R66 SERVICE BULLETIN SB-18A

SUBJECT: MRGB Output Yoke Retaining Plug

ROTORCRAFT AFFECTED: R66 Helicopters S/N 0004 thru 0707.

**FIGURE 1**

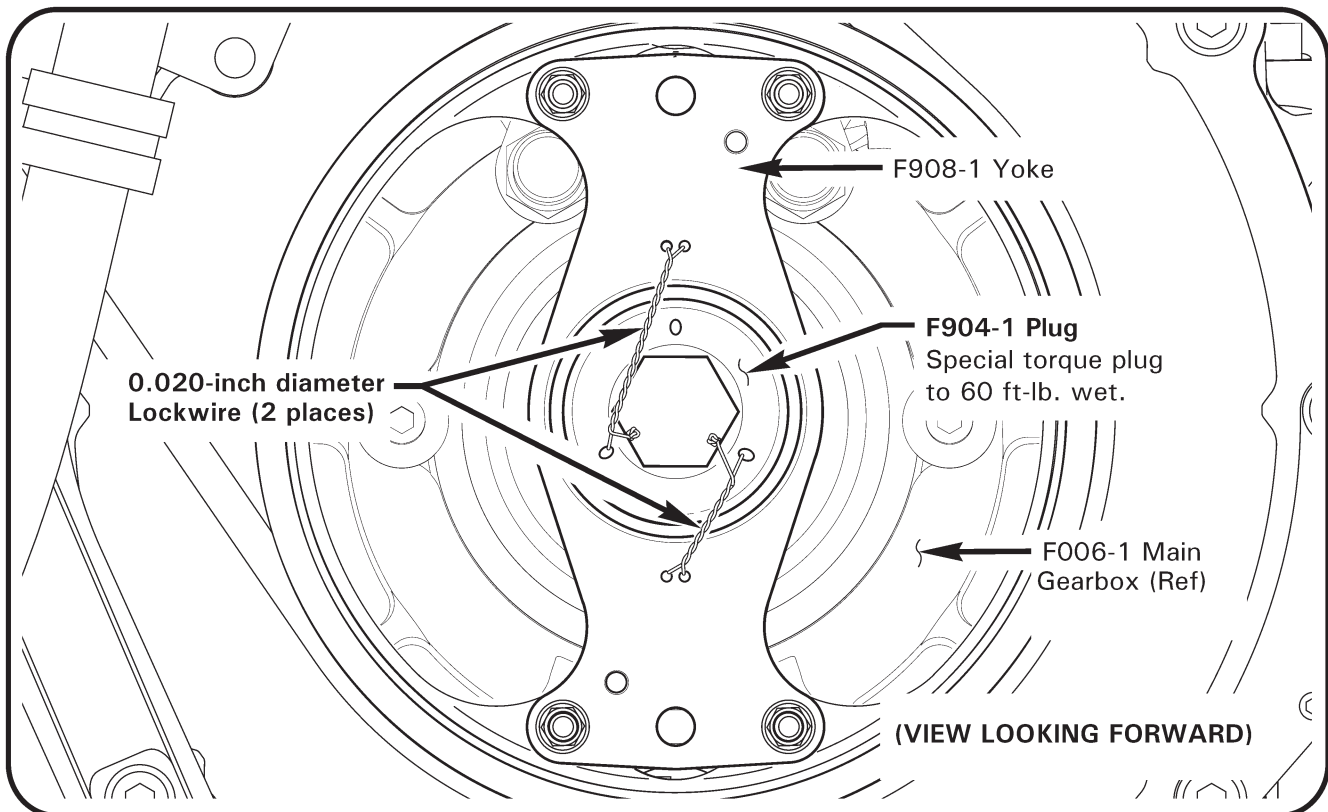
BACKGROUND: RHC has received an additional report of a loose F904-1 plug, which secures the F908-1 yoke to the main gearbox. The loosened plug caused the fanwheel to move aft and contact the scroll, followed by fanwheel failure. The yoke experiences higher loads on helicopters with air conditioning due to belt tension which may cause the plug to loosen. This bulletin requires increasing the plug torque and installing additional lockwire. SB-18A has reduced the compliance time due to the additional report.

1. Remove tailcone cowling per R66 Maintenance Manual (MM) § 53-23.
2. Refer to R66 Illustrated Parts Catalog (IPC) Figure 79-1. Remove hardware securing aft F305-5 inlet to scroll assembly; rest inlet on F196-1 fan shaft.
3. Refer to IPC Figure 65-1. Remove forward C947-3 flex plate assembly, noting hardware removed. Remove intermediate C947-3 flex plate assembly, noting hardware removed. Carefully maneuver fan shaft aft to access main gearbox's F908-1 yoke.
4. Refer to Figure 1. Set rotor brake. Remove and discard lockwire securing F904-1 plug to yoke and remove plug using a 3/4-inch hex-bit socket. Visually inspect forward C947-3 flex plate assembly and plug for damage. Order replacement parts from [RHC Customer Service](#) if damage is found.
5. Apply light coat of A257-9 anti-seize to plug threads, install plug in gearbox, and special torque plug to 60 ft-lb wet.

6. In two places, install 0.020-inch diameter lockwire and safety plug to yoke with pigtails inside recess of plug as shown.
7. Install forward C947-3 flex plate assembly, using hardware removed (replace palnuts). Standard torque hardware per MM § 20-32 and torque stripe per MM Figure 5-1. Ensure safety wire is not contacting flex plate.
8. Install and shim intermediate C947-3 flex plate assembly per MM § 65-30.
9. Install hardware securing aft F305-5 inlet to scroll assembly. Verify 0.10 inch minimum gap between fanwheel assembly and inlet.
10. Install tailcone cowling per MM § 53-23.
11. Make appropriate maintenance record entries. No change to helicopter weight and balance.
